PLANNING REF : 253071

22 Canberra Lake Way

Objection to the above mentioned plan

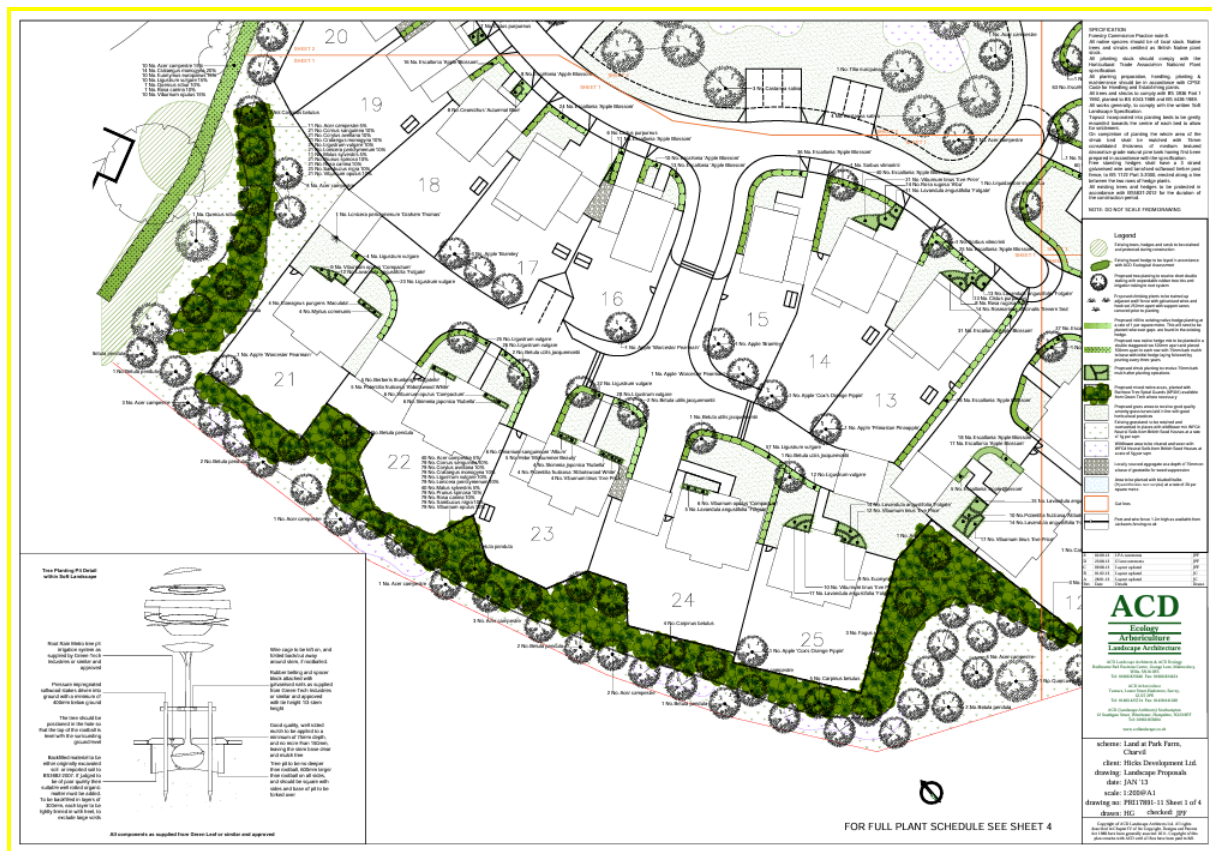
The current proposal fails to deliver the 5-10m landscape buffer which formed part of Hicks Development Ltd plan (Ref: 143292) that was eventually approved on appeal.

- **Privacy and Outlook:** The removal of this buffer results in an unacceptable level of overlooking, as it seriously reduces privacy and outlook for the affected houses. It is made worse because the proposed housing density at the boundary is significantly higher than the grain of the existing development.
- **Consistency of Character:** All plots and green spaces in Canberra Lake Way adhere strictly to the only landscaping plan that formed part of application 143292. By not delivering this buffer, the developer is creating a jarring transition that fails to "relate well to neighboring properties" as required by the WBC Design Guide.
- **Biodiversity:** The loss of this green corridor represents a net loss to local biodiversity, contrary to current national planning policy requirements for Biodiversity Net Gain.

I include below a screenshot of the only landscaping plan ever submitted for approval, showing the buffer that has not been delivered. This buffer was intended to be a fundamental condition of the plan, to protect the residential amenity of homes on Canberra Lake Way, and was a key reason for our purchase of our property in the first place. The original can be found as part of planning application 143292, named "F20142503pl PRI17891-11E-sheet1" and then sheet2, sheet3 and sheet4.

1. Reinstatement of the full 5-10m landscape buffer along the development's border with Canberra Lake Way.
2. Dispersal of affordable housing units across the entire site.
3. Replanning of parking capacity to account for tandem and garage spaces, to ensure sufficient future capacity for residents, and adequate visitor spaces.
4. A painted crossing and other suitable traffic calming measures to be implemented on Park Lane before the commencement of any residential construction work.
5. Relocation of the substation away from existing residential boundaries.
